2020 CNMI 305(b) and 303(d) INTEGRATED WATER QUALITY ASSESSMENT REPORT – RESPONSE TO PUBLIC COMMENTS

SUMMARY OF PUBLIC COMMENTS AND BECQ RESPONSES

C.2.1. Waterbody Segmentation - Watershed Approach:

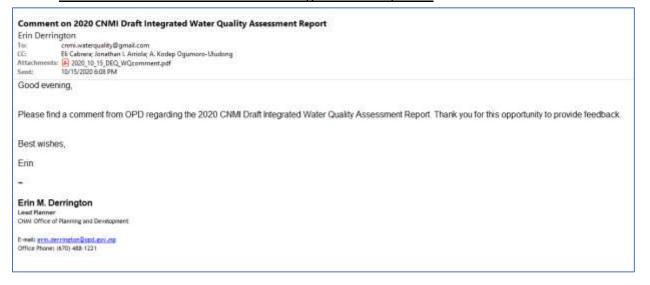
- DCRM is expecting a new digital elevation model from the incoming LiDAR expected to arrive by the end of this year.
 - Response: Yes, WQS/NPS staff requested that the NOAA CZM coordinator request that this new LiDAR data be collected during one of our collaborative Watershed Working Group discussions. This will allow BECQ to differentiate watersheds throughout the archipelago and to create detailed maps of watersheds and streams documenting survey data. We are very happy to note that NOAA plans to provide this new data in time for the next reporting cycle.
